Response to Observations Received

Proposed Repowering of
the Existing Kilgarvan Wind
Farm (ABP Ref-319741)

Project Number: **21107-a**

Prepared By: **MKO
Tuam Road
Galway
Ireland
H91 VW84**

Figure 2.2 – Poorly Defined Wide Windfarm Access onto N22 Mainline

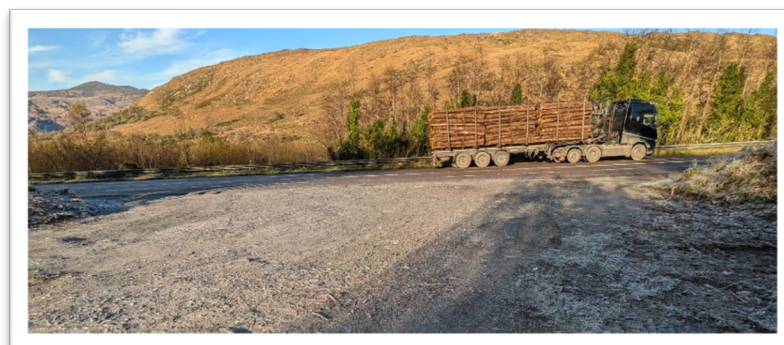
Location: Site Access Approach to N22 Mainline

The unusually wide (and unregulated) access junction may be challenging for drivers engaged in windfarm construction or operation activity to identify on all approaches. This could lead to driver confusing, unexpected braking and failing to stop type collisions.

Figure 2.3 – Eastbound N22 Approach to Sight Access Illustrating Right Turning Risk

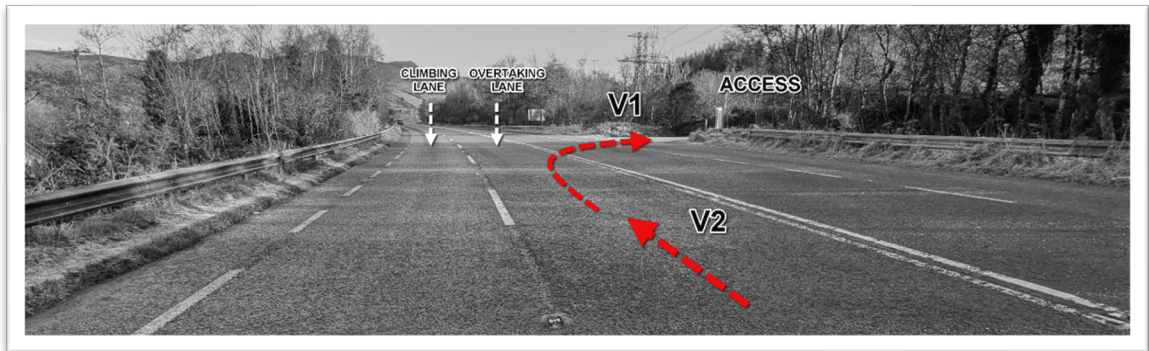
Location: N22 Eastbound Approach to Windfarm Access

Driver's unexpectedly slowing down whilst attempting to execute a right turn into the windfarm access from the climbing lane could lead to rear end shunt type collisions on the N22.
